## HARYANA RAIL INFRASTRUCTURE DEVELOPMENT CORPORATION LIMITED

**Tender No.:** Tender No: HORC/HRIDC/C-6A/2026

### CORRIGENDUM NO. 2

**Name of Work: Contract Package C-6A:** Design and Construction of Civil Works (Earthwork, Bridges, Station Buildings, Retaining Walls & other miscellaneous Works) and General Electrical Services works from km 61.50 to km 94.00 between New Patli & New Asaudha stations and connectivities from Badsa Station of HORC to existing Sultanpur station and Mandothi station of HORC to existing Asaudha Station in connection with laying of New BG Double Railway line of HORC Project.

**TITLE:-** CONCEPTUAL GENERAL ARRANGEMENT DRAWING  
PROPOSED RUB BRIDGE NO. 183  
1 x 12.2m PSC U SLAB CH: 69683.047m

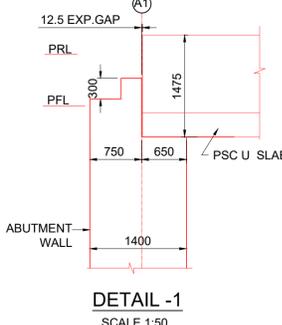
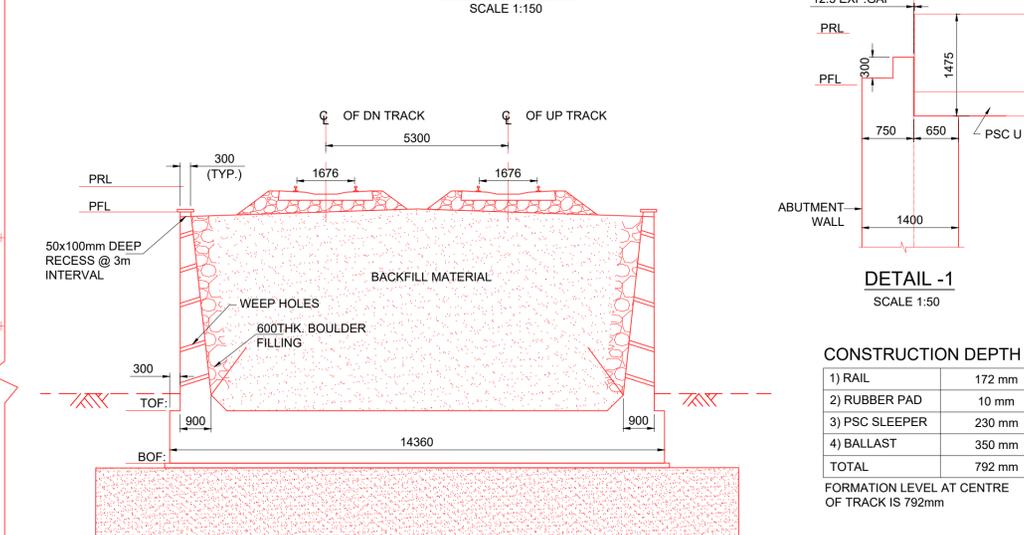
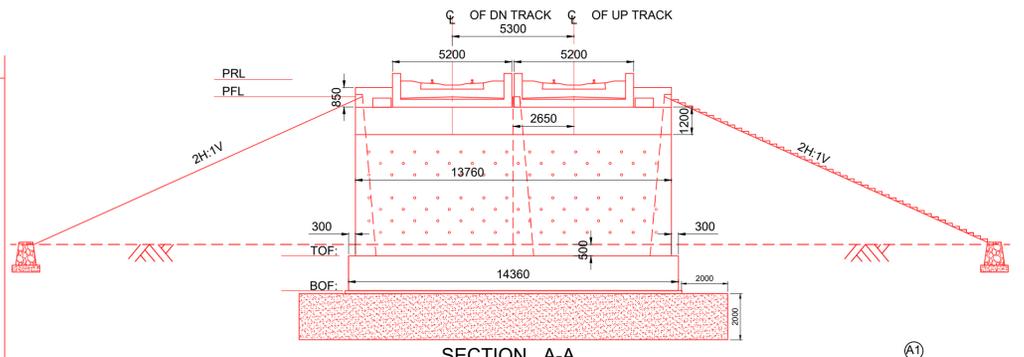
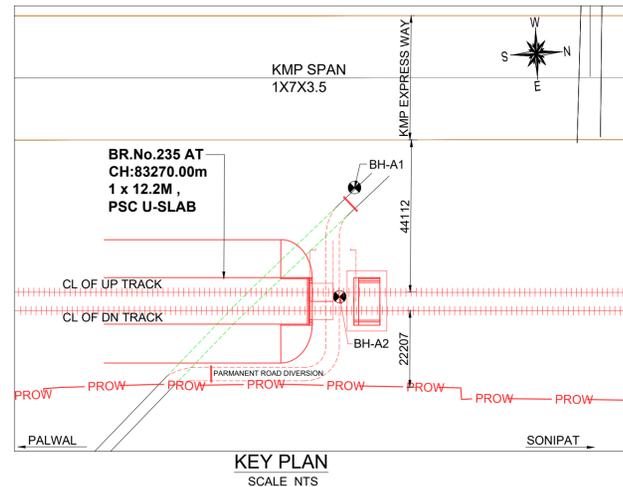
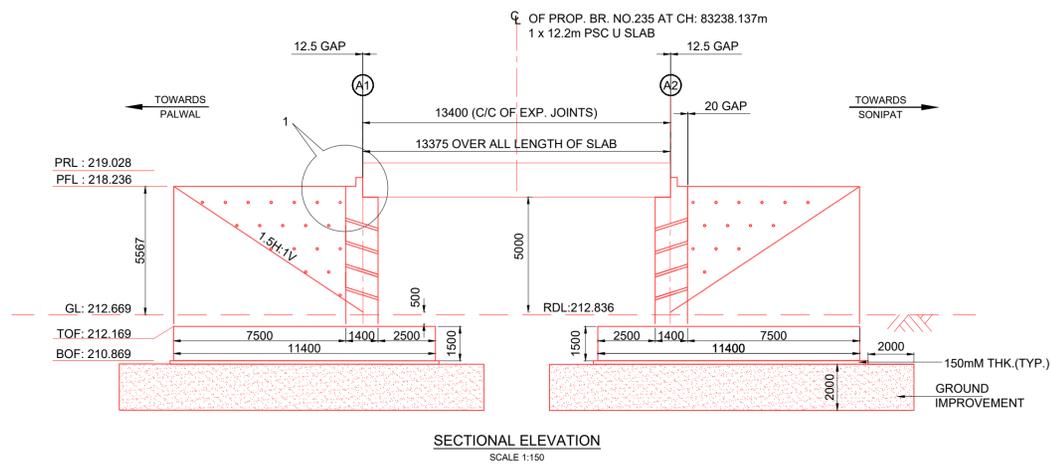
I. CIVIL DRAWINGS																																	
4.2.1 MAJOR BRIDGES- MAIN LINE																																	
S. No.	TITLE	DRAWING NO.																															
3	Conceptual general arrangement drawing for RUB Bridge no 183 Span 1x12.2 PSC U SLAB at Ch: 69683.047	GC-HRIDC-C6A-DRW-BRD-GAD-01183_A0																															
16	Conceptual general arrangement drawing for RUB Bridge No. 235 Span 1x12.2 PSC U SLAB at Ch: 83238.137	GC-HRIDC-C6A-DRW-BRD-GAD_01235_A0

I. CIVIL DRAWINGS																																	
4.2.1 MAJOR BRIDGES- MAIN LINE																																	
S. No.	TITLE	DRAWING NO.																															
3	Conceptual general arrangement drawing for RUB Bridge no 183 Span 1x12.2 PSC U SLAB at Ch: 69683.047	GC-HRIDC-C6A-DRW-BRD-GAD-01183_AI																															
16	Conceptual general arrangement drawing for RUB Bridge No. 235 Span 1x12.2 PSC U SLAB at Ch: 83270.000	GC-HRIDC-C6A-DRW-BRD-GAD_01235_AI																															
24	Part 2, Section VII-8: Tender Drawings and Documents, I. Civil Drawings, 5. Miscellaneous Drawings (Conceptual Plans) Drawings, S. No. 37	<table border="1"> <thead> <tr> <th colspan="3">I. CIVIL DRAWINGS</th> </tr> <tr> <th colspan="3">5. MISCELLANEOUS DRAWINGS (CONCEPTUAL PLANS)</th> </tr> <tr> <th>S. No.</th> <th>TITLE</th> <th>DRAWING NO.</th> </tr> </thead> <tbody> <tr> <td>37</td> <td>Conceptual Plan OHE portal for OWG bridges</td> <td>GC-HRIDC-SK-GEN-035</td> </tr> </tbody> </table>	I. CIVIL DRAWINGS			5. MISCELLANEOUS DRAWINGS (CONCEPTUAL PLANS)			S. No.	TITLE	DRAWING NO.	37	Conceptual Plan OHE portal for OWG bridges	GC-HRIDC-SK-GEN-035	<p>Tender drawing for Miscellaneous Drawings (Conceptual Plans) at S. No. 37 is replaced with the following and is enclosed in <b>Attachment No. 3</b> of Corrigendum No. 2.</p> <table border="1"> <thead> <tr> <th colspan="3">I. CIVIL DRAWINGS</th> </tr> <tr> <th colspan="3">5. MISCELLANEOUS DRAWINGS (CONCEPTUAL PLANS)</th> </tr> <tr> <th>S. No.</th> <th>TITLE</th> <th>DRAWING NO.</th> </tr> </thead> <tbody> <tr> <td>37</td> <td>Conceptual Plan OHE portal for Bridge and viaduct</td> <td>GC-HRIDC-SK-GEN-038A</td> </tr> </tbody> </table>	I. CIVIL DRAWINGS			5. MISCELLANEOUS DRAWINGS (CONCEPTUAL PLANS)			S. No.	TITLE	DRAWING NO.	37	Conceptual Plan OHE portal for Bridge and viaduct	GC-HRIDC-SK-GEN-038A

**TITLE:-** CONCEPTUAL GENERAL ARRANGEMENT DRAWING  
 PROPOSED RUB BRIDGE NO. 235  
 1 x 12.2m PSC U SLAB CH: 83270.00M

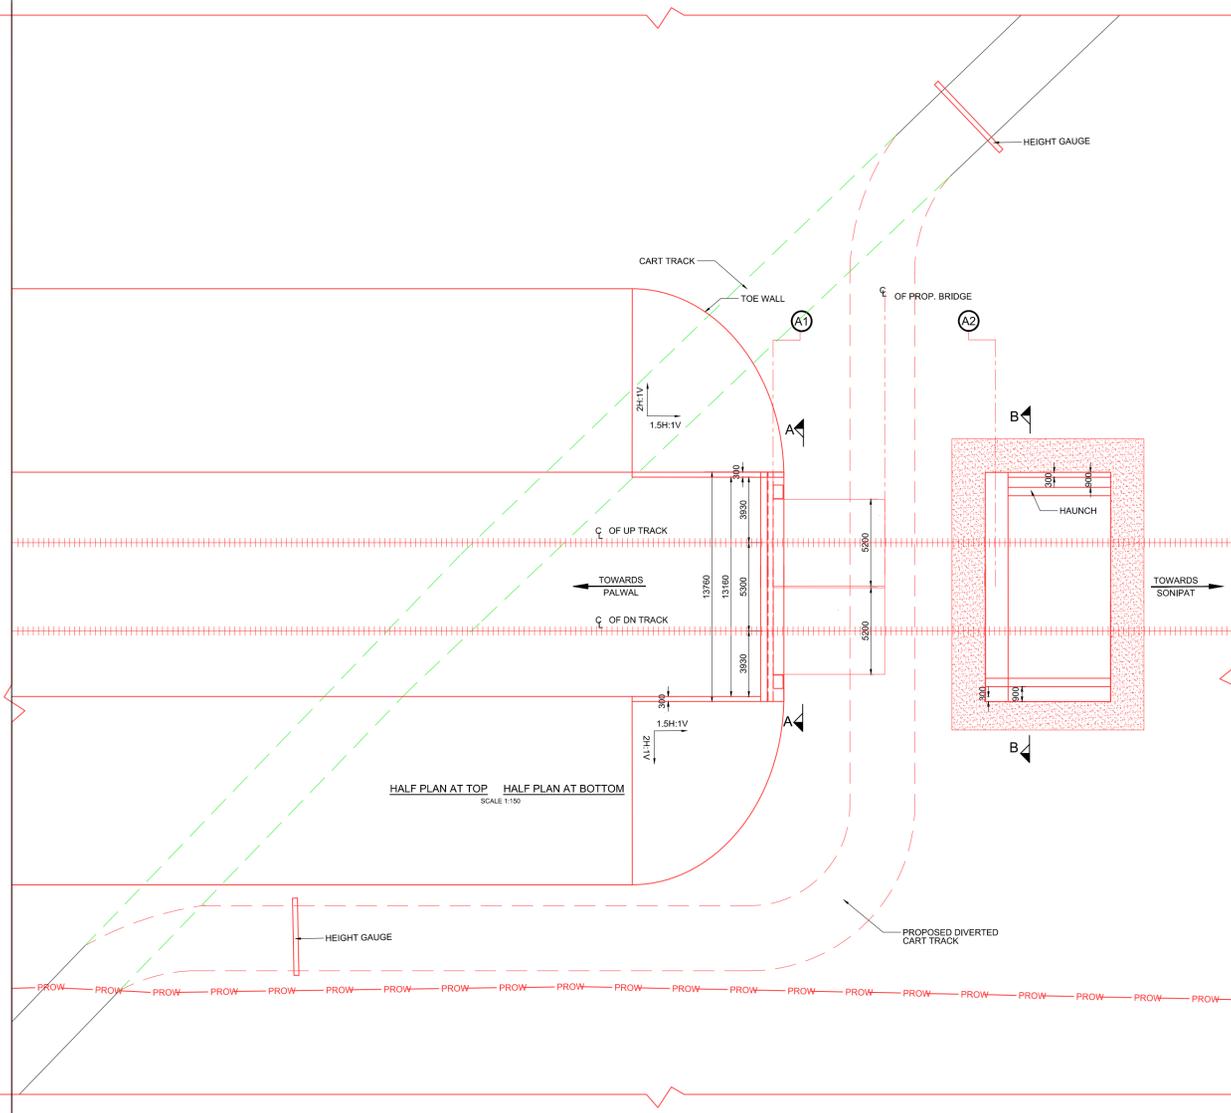
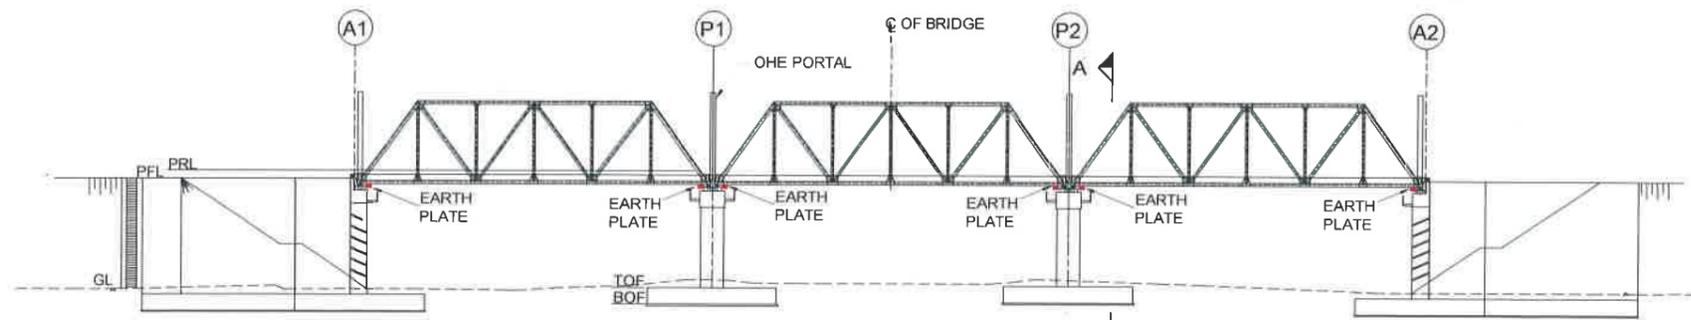
11.	235	83270.000	RUB	PSC U SLAB	1x12.2																																		
20.	4B	3005.83	RUB	RCC Box (No. x span x Height)	1x5x4.565 +2x9x5.65 +1x5x4.65

S. No.	Tender Document Part / Section/ Clause No.	Description of Existing Clause	Modified Description of Existing Clause / New Clause																														
23	Part 2, Section VII-8: Tender Drawings and Documents, I. Civil Drawings, 4.2.1 Major Bridges-Main Line, S. No. 3 and S. No. 16	<table border="1"> <thead> <tr> <th colspan="3">I. CIVIL DRAWINGS</th> </tr> <tr> <th colspan="3">4.2.1 MAJOR BRIDGES- MAIN LINE</th> </tr> <tr> <th>S. No.</th> <th>TITLE</th> <th>DRAWING NO.</th> </tr> </thead> <tbody> <tr> <td>3</td> <td>Conceptual general arrangement drawing for RUB Bridge no 183 Span 1x12.2 PSC U SLAB at Ch: 69683.047</td> <td>GC-HRIDC-C6A-DRW-BRD-GAD-01183_A0</td> </tr> <tr> <td>16</td> <td>Conceptual general arrangement drawing for RUB Bridge No. 235 Span 1x12.2 PSC U SLAB at Ch: 83238.137</td> <td>GC-HRIDC-C6A-DRW-BRD-GAD_01235_A0</td> </tr> </tbody> </table>	I. CIVIL DRAWINGS			4.2.1 MAJOR BRIDGES- MAIN LINE			S. No.	TITLE	DRAWING NO.	3	Conceptual general arrangement drawing for RUB Bridge no 183 Span 1x12.2 PSC U SLAB at Ch: 69683.047	GC-HRIDC-C6A-DRW-BRD-GAD-01183_A0	16	Conceptual general arrangement drawing for RUB Bridge No. 235 Span 1x12.2 PSC U SLAB at Ch: 83238.137	GC-HRIDC-C6A-DRW-BRD-GAD_01235_A0	<p>Tender drawing for Major Bridges- Main Line at S. No. 3 and 16 are replaced with the following and is enclosed in <b>Attachment No. 3</b> of Corrigendum No. 2.</p> <table border="1"> <thead> <tr> <th colspan="3">I. CIVIL DRAWINGS</th> </tr> <tr> <th colspan="3">4.2.1 MAJOR BRIDGES- MAIN LINE</th> </tr> <tr> <th>S. No.</th> <th>TITLE</th> <th>DRAWING NO.</th> </tr> </thead> <tbody> <tr> <td>3</td> <td>Conceptual general arrangement drawing for RUB Bridge no 183 Span 1x12.2 PSC U SLAB at Ch: 69683.047</td> <td>GC-HRIDC-C6A-DRW-BRD-GAD-01183_AI</td> </tr> <tr> <td>16</td> <td>Conceptual general arrangement drawing for RUB Bridge No. 235 Span 1x12.2 PSC U SLAB at Ch: 83270.000</td> <td>GC-HRIDC-C6A-DRW-BRD-GAD_01235_AI</td> </tr> </tbody> </table>	I. CIVIL DRAWINGS			4.2.1 MAJOR BRIDGES- MAIN LINE			S. No.	TITLE	DRAWING NO.	3	Conceptual general arrangement drawing for RUB Bridge no 183 Span 1x12.2 PSC U SLAB at Ch: 69683.047	GC-HRIDC-C6A-DRW-BRD-GAD-01183_AI	16	Conceptual general arrangement drawing for RUB Bridge No. 235 Span 1x12.2 PSC U SLAB at Ch: 83270.000	GC-HRIDC-C6A-DRW-BRD-GAD_01235_AI

**TITLE:-**  
CONCEPTUAL PLAN  
OHE PORTAL FOR BRIDGE AND VIADUCT

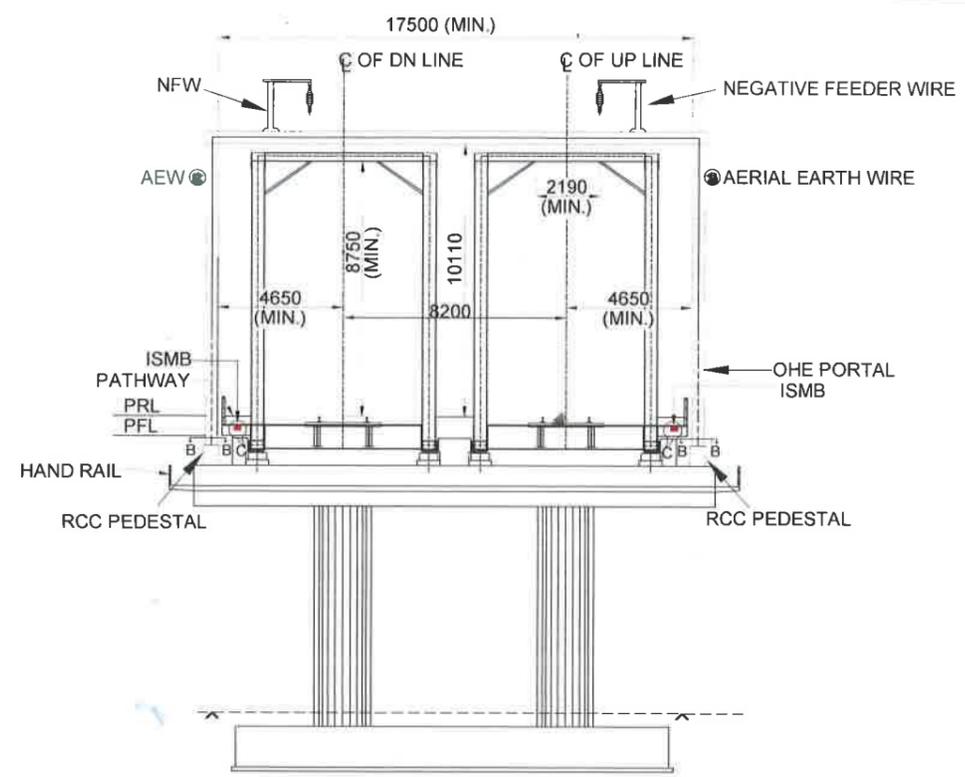
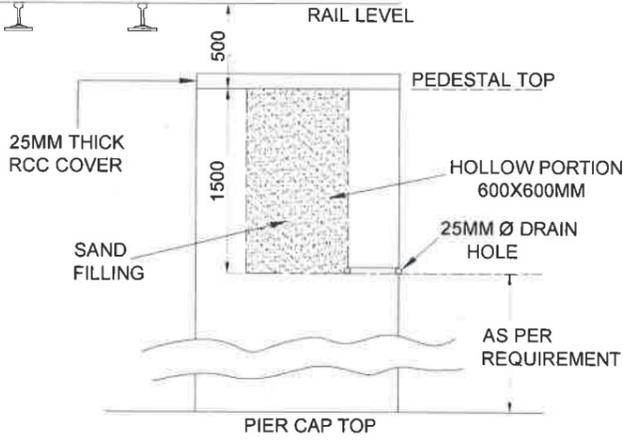
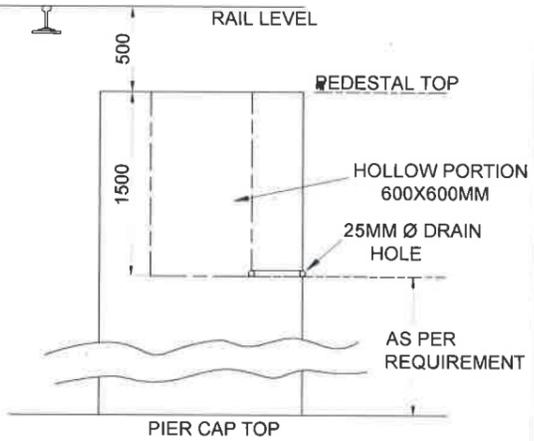
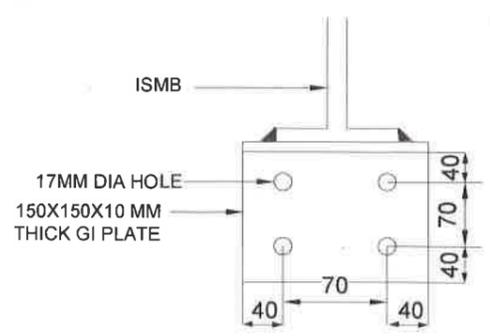
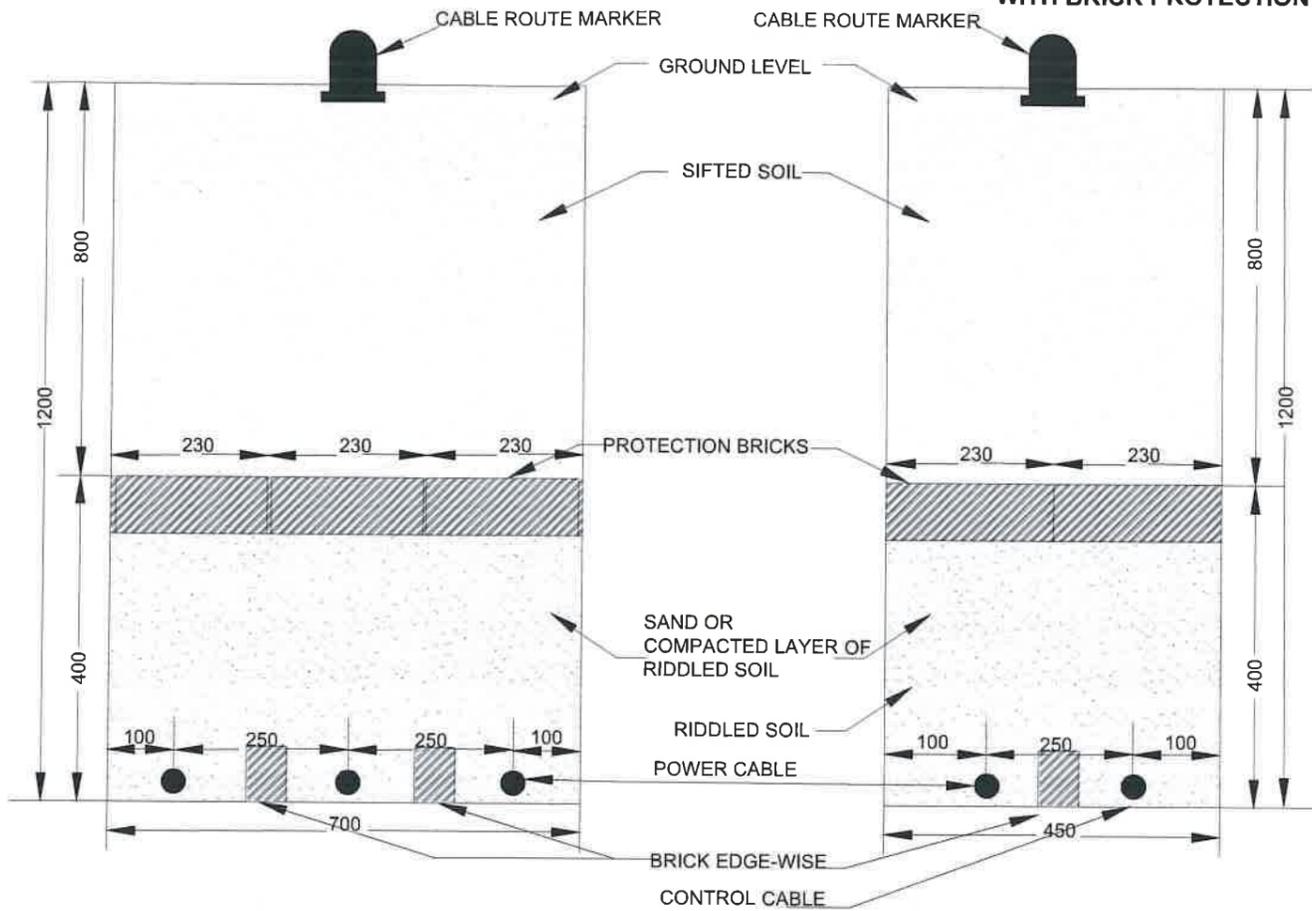
I. CIVIL DRAWINGS																																	
5. MISCELLANEOUS DRAWINGS (CONCEPTUAL PLANS)																																	
S. No.	TITLE	DRAWING NO.																															
37	Conceptual Plan OHE portal for OWG bridges	GC-HRIDC-SK-GEN-035

I. CIVIL DRAWINGS																																	
5. MISCELLANEOUS DRAWINGS (CONCEPTUAL PLANS)																																	
S. No.	TITLE	DRAWING NO.																															
37	Conceptual Plan OHE portal for Bridge and viaduct	GC-HRIDC-SK-GEN-038A

TITLE:-  
INDICATIVE CABLE ROUTE PLAN FOR LAYING OF  
CABLES IN THE GROUND & ROUTE MARKER

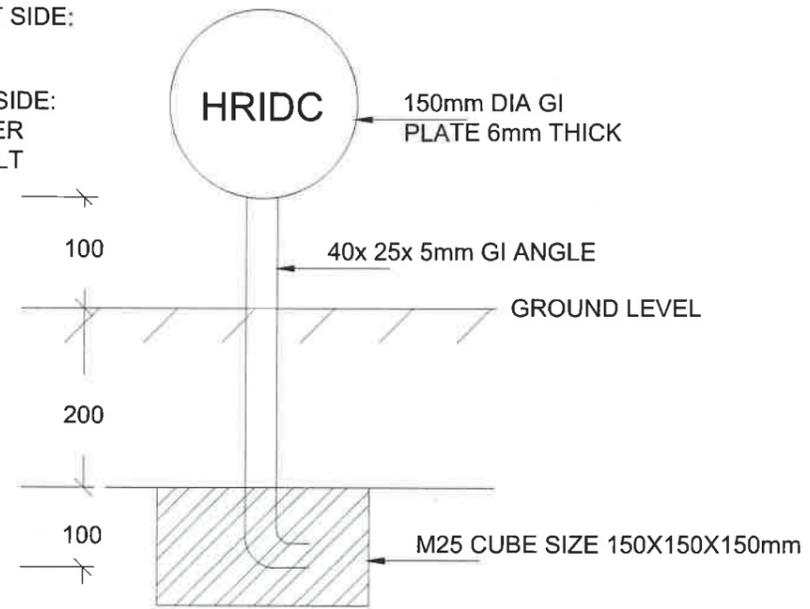
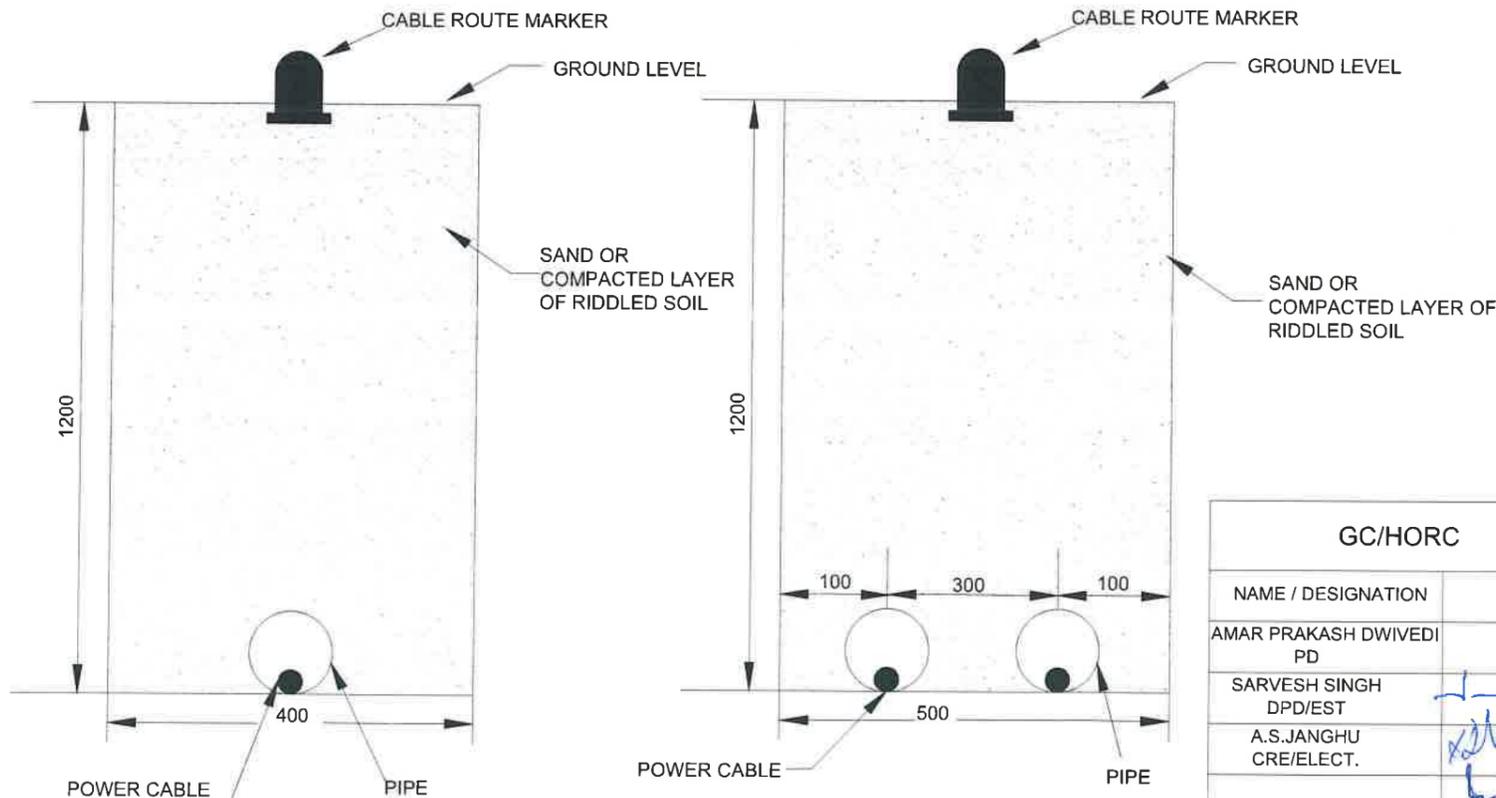
S. No.	Tender Document Part / Section/ Clause No.	Description of Existing Clause	Modified Description of Existing Clause / New Clause																		
25	Part 2, Section VII-8: Tender Drawings and Documents, II. General Electrical Services Drawings, S. No. 5	<table border="1"> <thead> <tr> <th colspan="3" data-bbox="488 288 1232 320">II. GENERAL ELECTRICAL SERVICES DRAWINGS</th> </tr> <tr> <th data-bbox="488 320 595 352">S. No.</th> <th data-bbox="595 320 992 352">TITLE</th> <th data-bbox="992 320 1232 352">DRAWING NO.</th> </tr> </thead> <tbody> <tr> <td data-bbox="488 352 595 456">5</td> <td data-bbox="595 352 992 456">Indicative cable route plan for laying of cables in the ground and router marker.</td> <td data-bbox="992 352 1232 456">GC-HRIDC-C-6A-I (ELE-005_A0)</td> </tr> </tbody> </table>	II. GENERAL ELECTRICAL SERVICES DRAWINGS			S. No.	TITLE	DRAWING NO.	5	Indicative cable route plan for laying of cables in the ground and router marker.	GC-HRIDC-C-6A-I (ELE-005_A0)	<p>Tender drawing for General Electrical Services Drawings at S. No. 5 is replaced with the following and is enclosed in <b>Attachment No. 3</b> of Corrigendum No. 2</p> <table border="1"> <thead> <tr> <th colspan="3" data-bbox="1258 352 1989 384">II. GENERAL ELECTRICAL SERVICES DRAWINGS</th> </tr> <tr> <th data-bbox="1258 384 1366 416">S. No.</th> <th data-bbox="1366 384 1762 416">TITLE</th> <th data-bbox="1762 384 2065 416">DRAWING NO.</th> </tr> </thead> <tbody> <tr> <td data-bbox="1258 416 1366 528">5</td> <td data-bbox="1366 416 1762 528">Indicative cable route plan for laying of cables in the ground and router marker</td> <td data-bbox="1762 416 2065 528">GC-HRIDC-DRW-ELE-003A</td> </tr> </tbody> </table>	II. GENERAL ELECTRICAL SERVICES DRAWINGS			S. No.	TITLE	DRAWING NO.	5	Indicative cable route plan for laying of cables in the ground and router marker	GC-HRIDC-DRW-ELE-003A

II. GENERAL ELECTRICAL SERVICES DRAWINGS																					
S. No.	TITLE	DRAWING NO.																			
5	Indicative cable route plan for laying of cables in the ground and router marker.	GC-HRIDC-C-6A-I (ELE-005_A0)																			
II. GENERAL ELECTRICAL SERVICES DRAWINGS

S. No.	TITLE	DRAWING NO.																			
5	Indicative cable route plan for laying of cables in the ground and router marker	GC-HRIDC-DRW-ELE-003A																			
26	Part 2, Section VII-8: Tender Drawings and Documents, Item 5. Miscellaneous Drawings (Conceptual Plans), S. No. 17	<table border="1"> <thead> <tr> <th data-bbox="488 616 595 647">S. No.</th> <th data-bbox="595 616 969 647">TITLE</th> <th data-bbox="969 616 1232 647">DRAWING NO.</th> </tr> </thead> <tbody> <tr> <td data-bbox="488 647 595 727">17</td> <td data-bbox="595 647 969 727">Conceptual Plan for RCC duct of signalling cable</td> <td data-bbox="969 647 1232 727">GC-HRIDC-SK-GEN-017</td> </tr> </tbody> </table>	S. No.	TITLE	DRAWING NO.	17	Conceptual Plan for RCC duct of signalling cable	GC-HRIDC-SK-GEN-017	<table border="1"> <thead> <tr> <th data-bbox="1258 616 1366 647">S. No.</th> <th data-bbox="1366 616 1762 647">TITLE</th> <th data-bbox="1762 616 2065 647">DRAWING NO.</th> </tr> </thead> <tbody> <tr> <td data-bbox="1258 647 1366 687">17</td> <td colspan="2" data-bbox="1366 647 2065 687">Deleted</td> </tr> </tbody> </table>	S. No.	TITLE	DRAWING NO.	17	Deleted
